US.1 PEDESTRIAN OVERPASS STUDY

January 26th, 2000
July 7th, 2000 - Revised

RE: City of South Miami, Pedestrian Overpass
At South Dixie Highway (US-1) near Sunset Drive

The City of South Miami US 1 Pedestrian Overpass Study - Comments

SHEET No.
A1.00

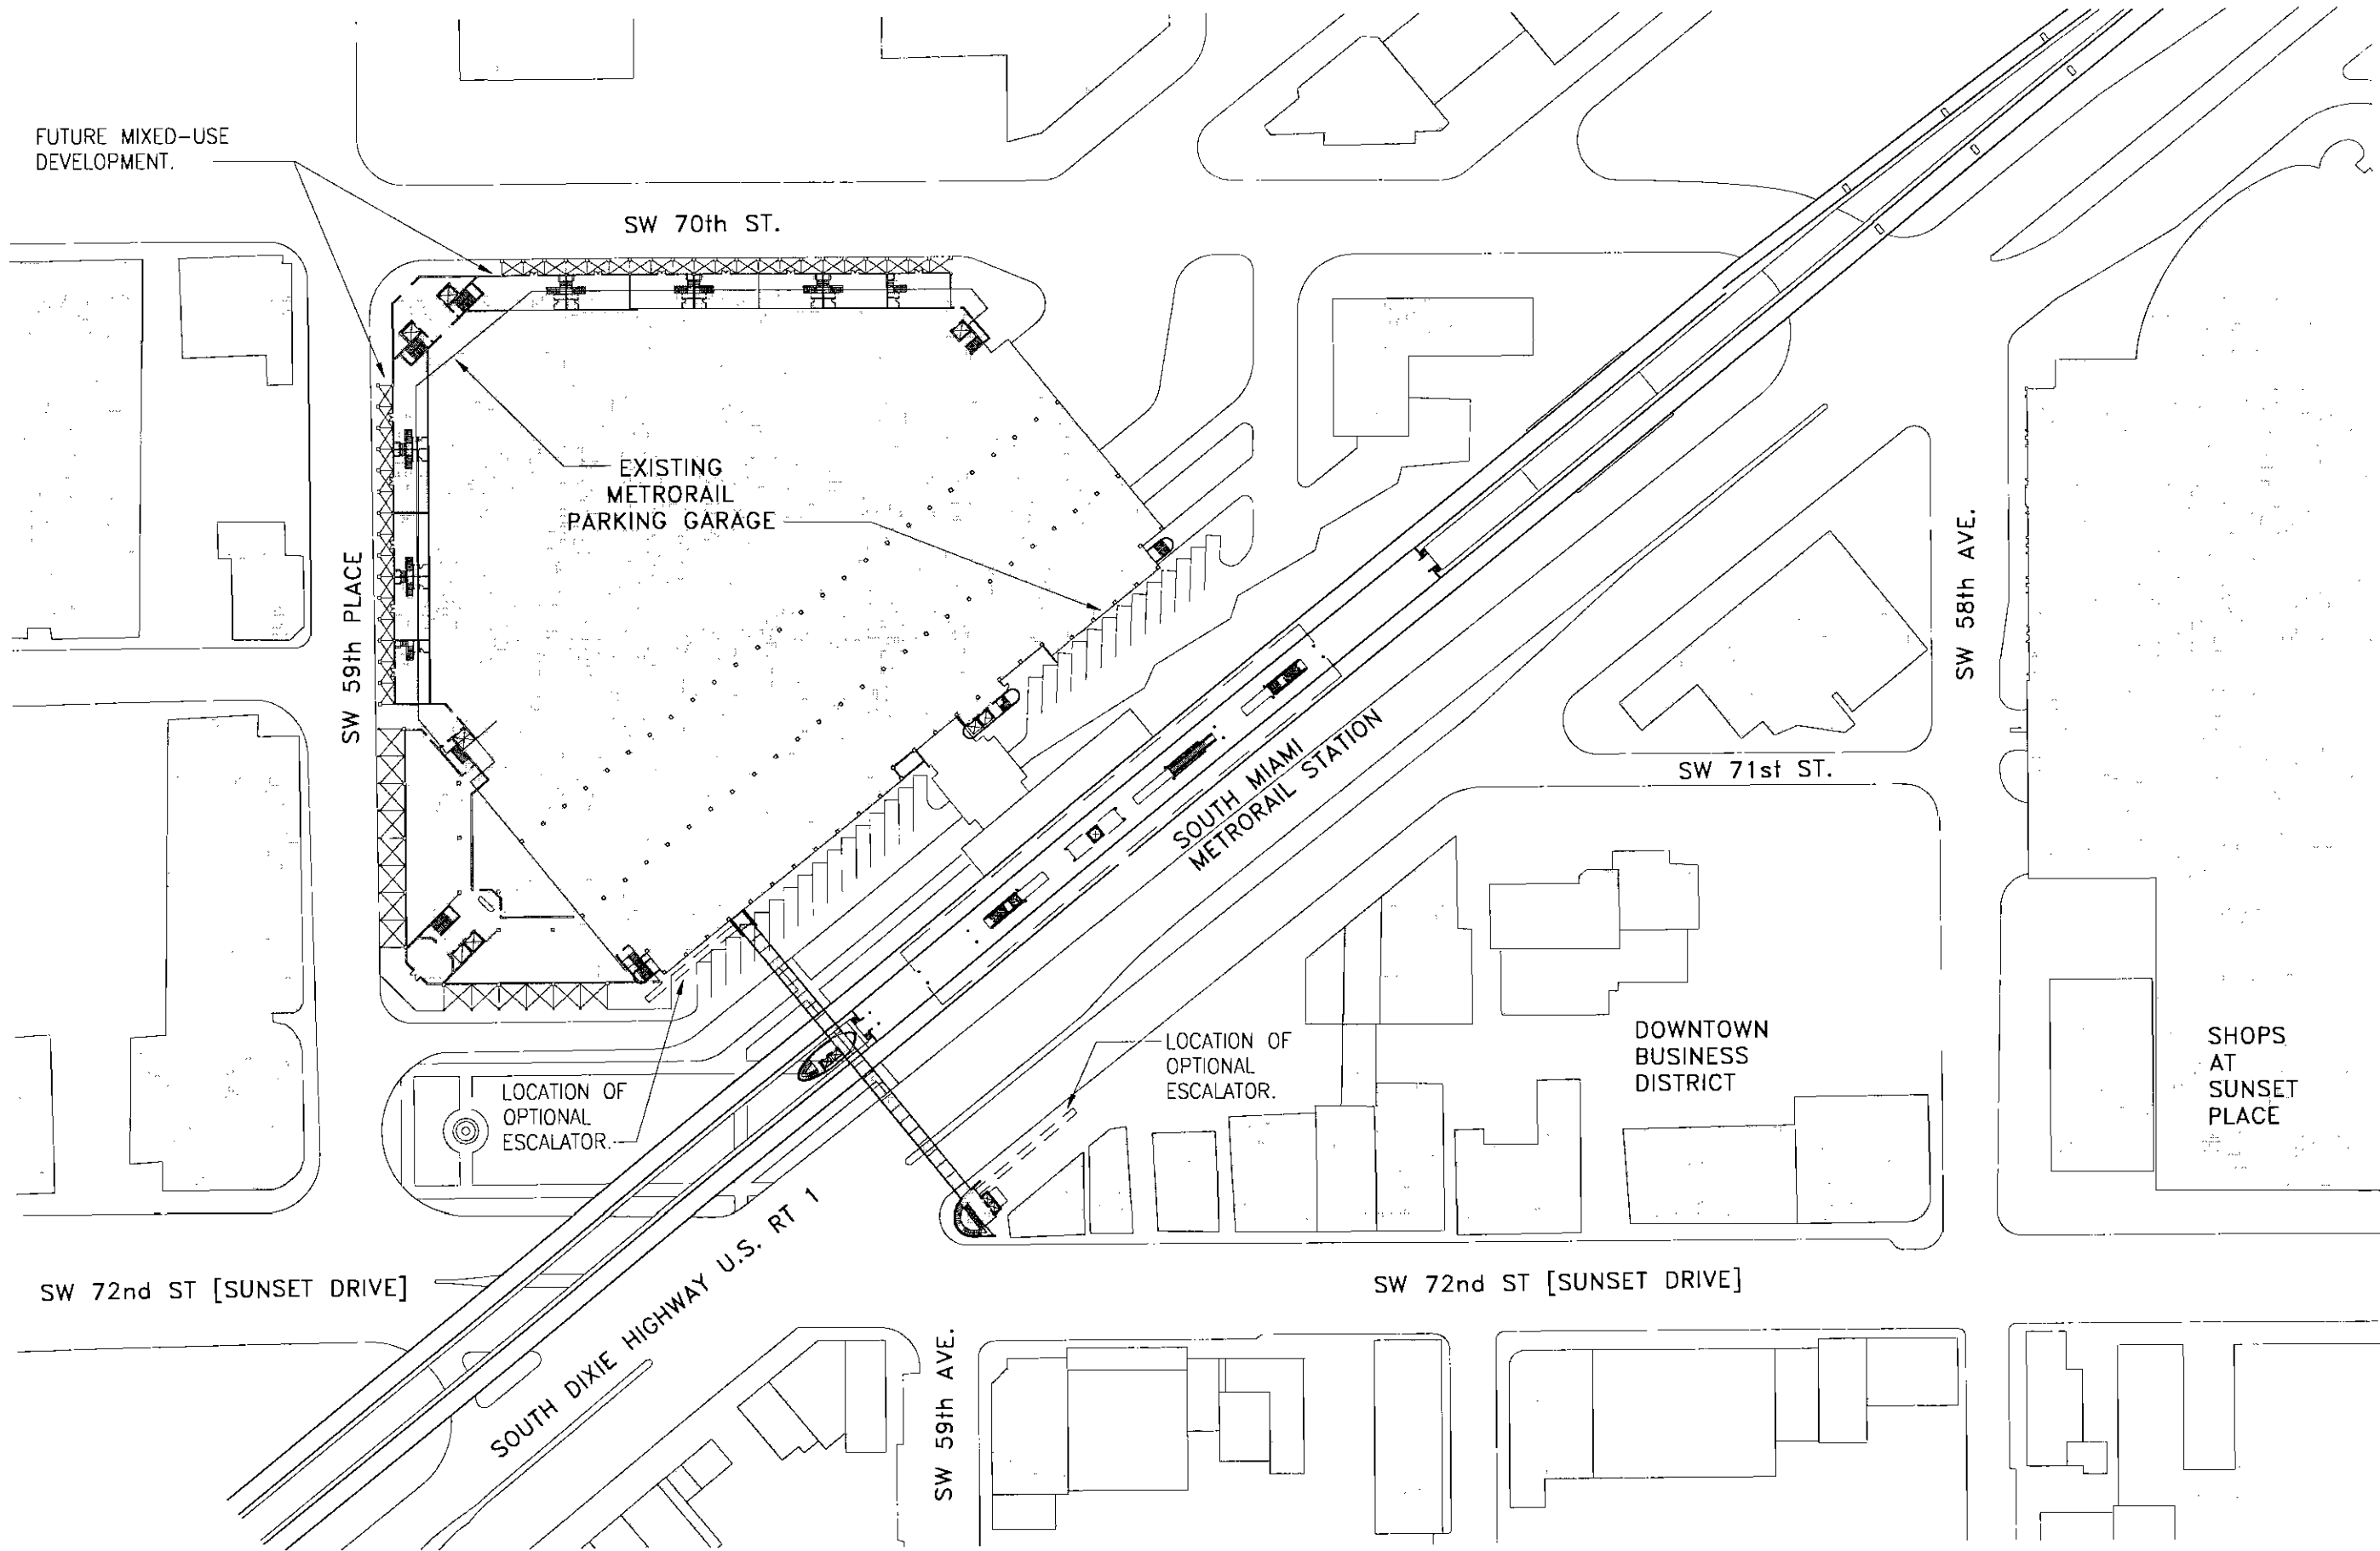
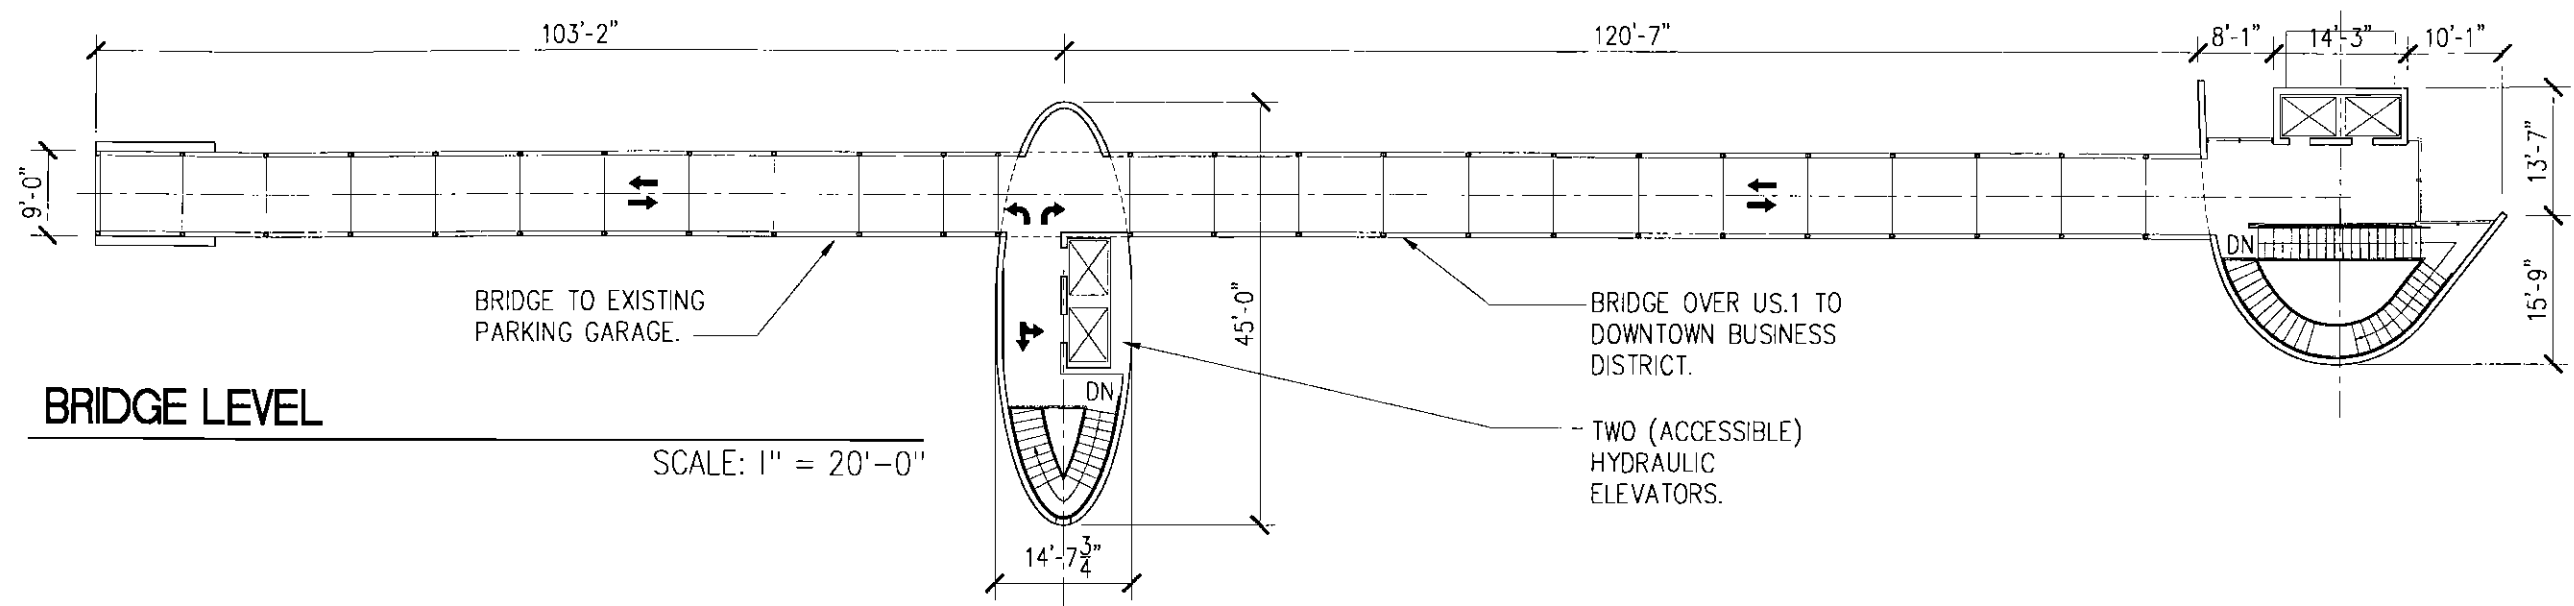
- Scheme "A" in Sheet A-1 and Scheme "B" in Sheet A-2 seem to meet FDOT criteria for horizontal and vertical clearances.
